Rev.	Date	By	Ckd	Description
I	17/08/2023	WN	DN	S4.56 Issue 2

30 Fairlight St, Fairlight
30 Fairlight St,
Fairlight, NSW 2094

- SCHEDULE OF CHANGES**
1. Planter and deepsoil reduced to accommodate relocation of mailbox for DDA compliance.
 2. Amendment to location of carpark lobby doors
 3. OSD tank extended to accommodate minimum volume as per Stormwater Engineer's report.
 4. Additional door added for compliance as alternate fire egress with NCC D2D6.
 5. Landscaping and planter replaced with terrace hardscape to accommodate OSD tank volume below.
 6. Wall of front terrace rationalised for buildability
 7. Window opening reconfigured.
 8. Internal layout reconfigured and rationalised
 9. Plant services added onto roof including AC condensers, hot water units and mechanical vent exhausts to be concealed with metal screen enclosure
 10. PV panels added.
 11. Skylights deleted.
 12. Solid access hatch cover amended to glazed hatch.
 13. Courtyard landscape amendment.

DEEP SOIL CALCULATIONS

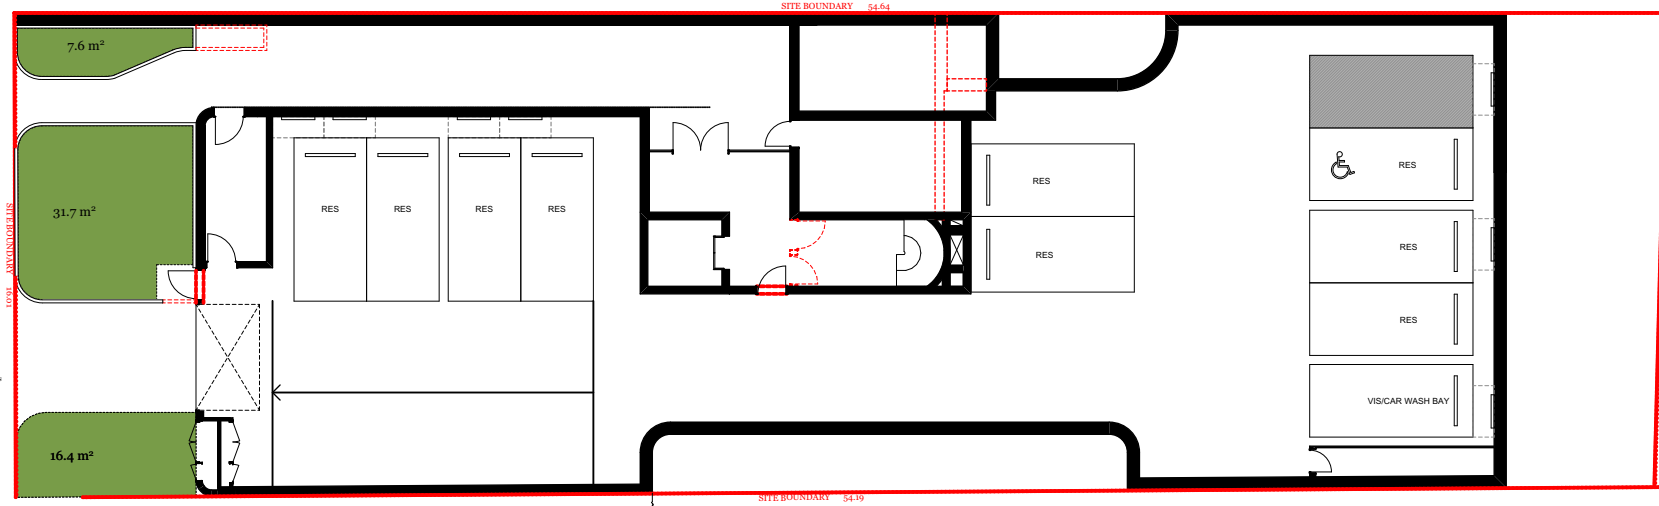
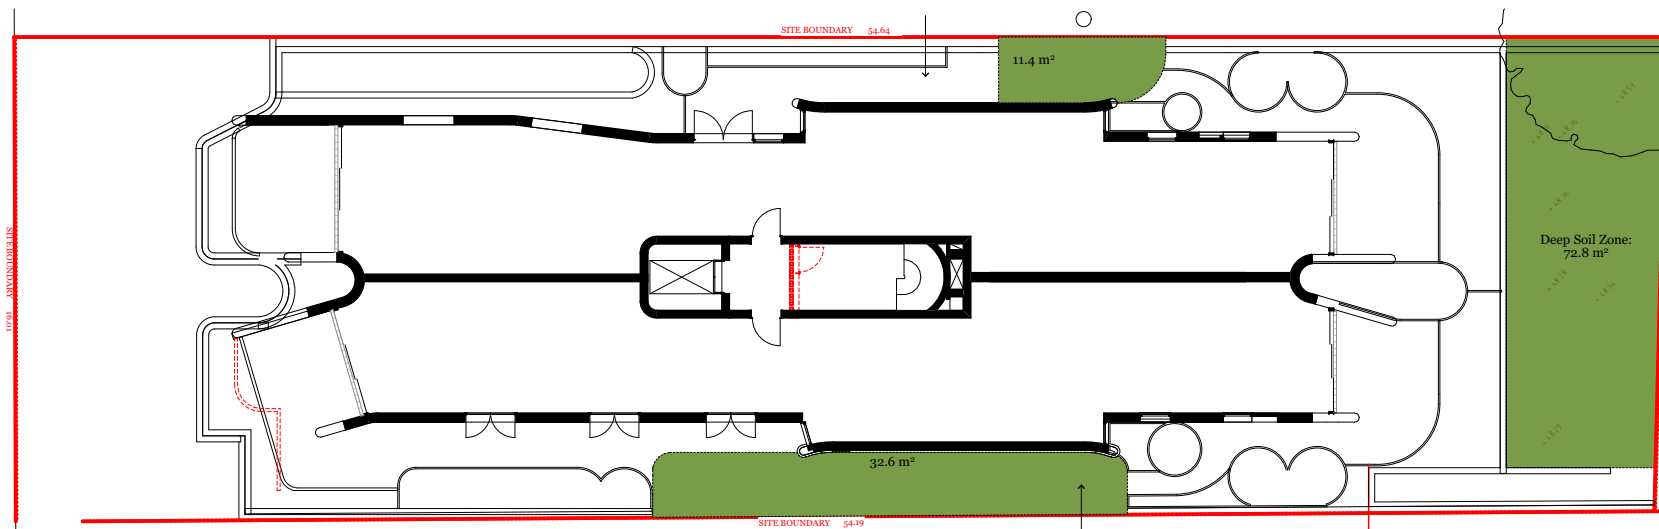
Basement Level
Proposed Deep Soil: 58.5sqm

Ground Floor
Proposed Deep Soil: 119.6sqm

Site Area	862sqm	
Area Required As Deep Soil	60.3sqm	7%
Area Approved As Deep Soil	178.1sqm	20.7%
Area Proposed As Deep Soil	172.5sqm	20.0%
